Aurora Reference
DA-2062-39
Case No. 2022-6048-00

RE: 26th Avenue (E-470 to The Aurora Highlands Parkway) ISP
Third Review Comment Response Letter

Review Comment Summary and Resolution Log

Pond Access Turn Template - South East of Main St

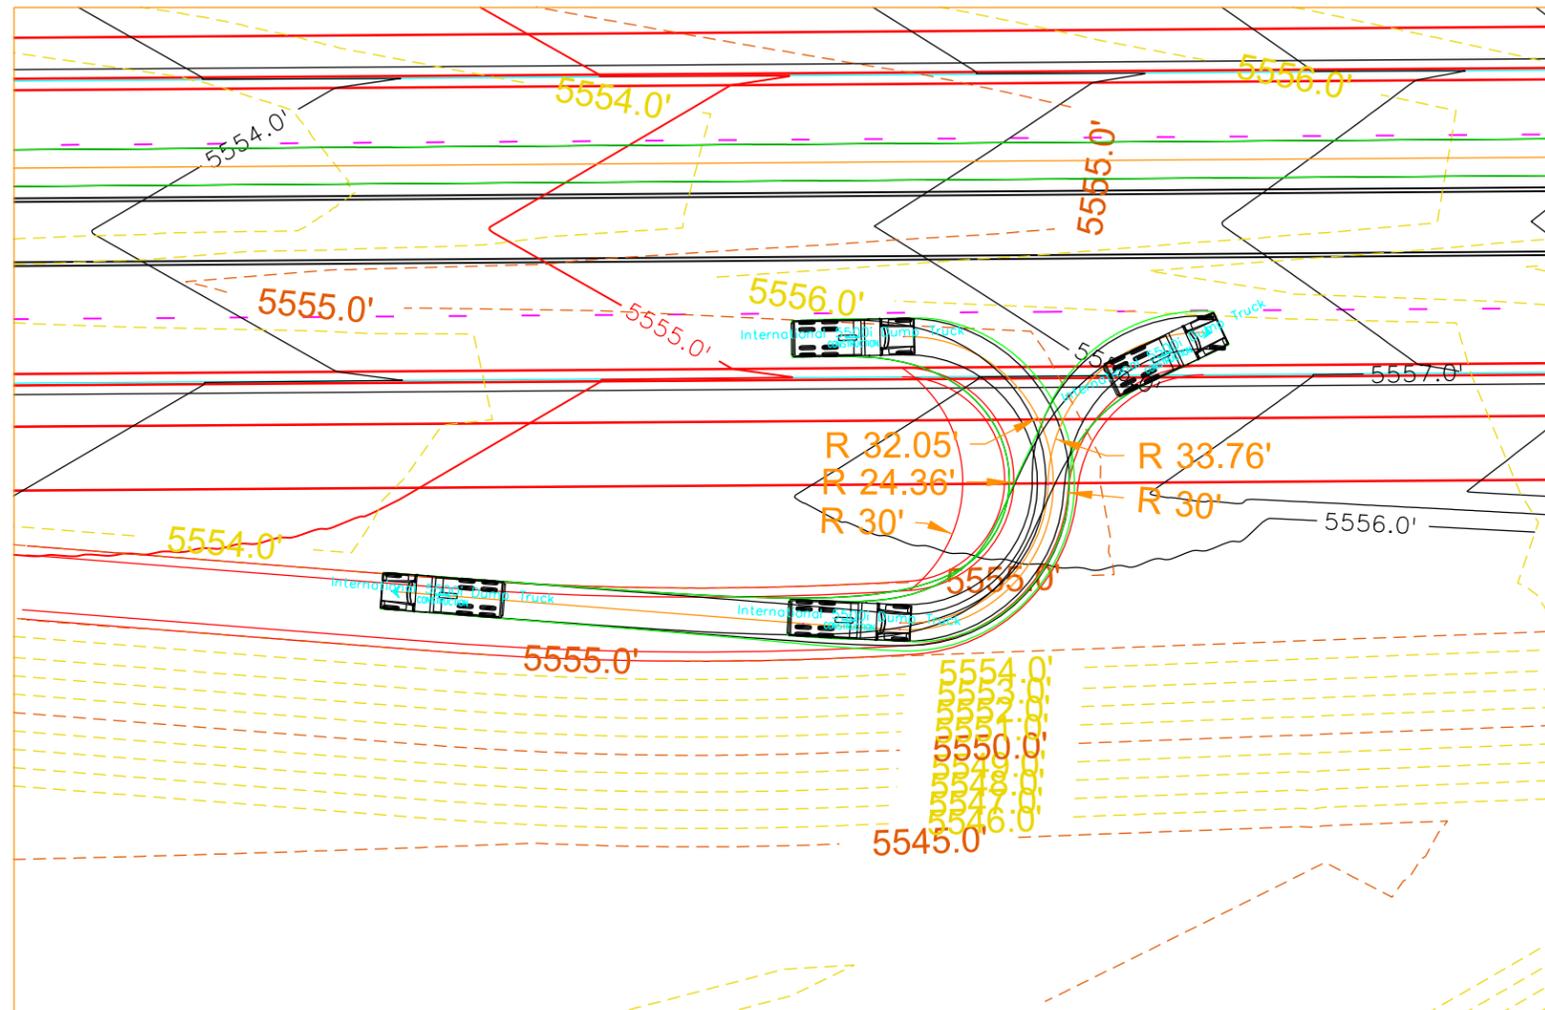
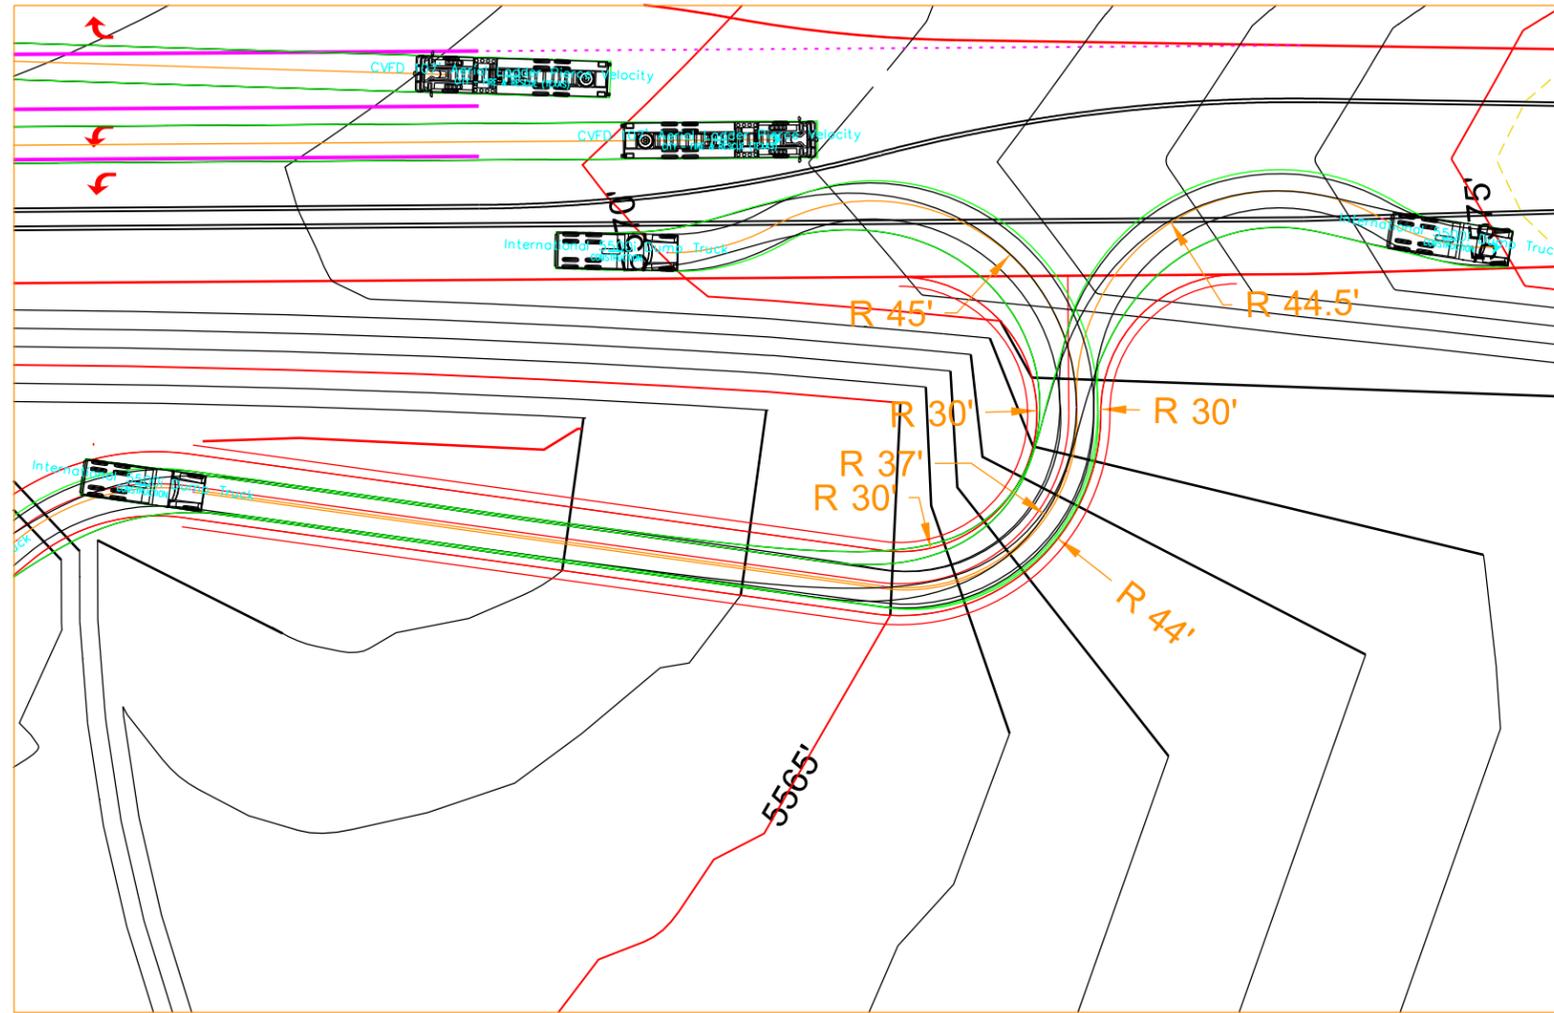
Iman Ghazali	Water	Planning Letter	Third Submission Review Sheet 2	It is unclear what the extents of the pond access road are. In addition, maintenance access must be provided to the bottom of the outlet structure, as well as to the top of the inlet structure (See Sheet 6).	A	Understood, will add appropriate maintenance access.	A	27-Apr-23	AJB	
Iman Ghazali	Water	Planning Letter	Third Submission Review Sheet 2	Identify the symbol noted on Sheet 5.	A	Callout added for PROPOSED SIGNAL POLE, TYP	A	26-Apr-23	GAB	
Iman Ghazali	Water	Planning Letter	Third Submission Review Sheet 2	City records do not show an existing sanitary manhole at the location noted on Sheet 6.	A	This is actually a water blowoff manhole. Removed SS from its symbology.	A	01-May-23	SC	
Iman Ghazali	Water	Planning Letter	Third Submission Review Sheet 2	The Site Plan will not be approved by Aurora Water until the Preliminary Drainage Report is approved.	A	Understood	A	26-Apr-23	AJB
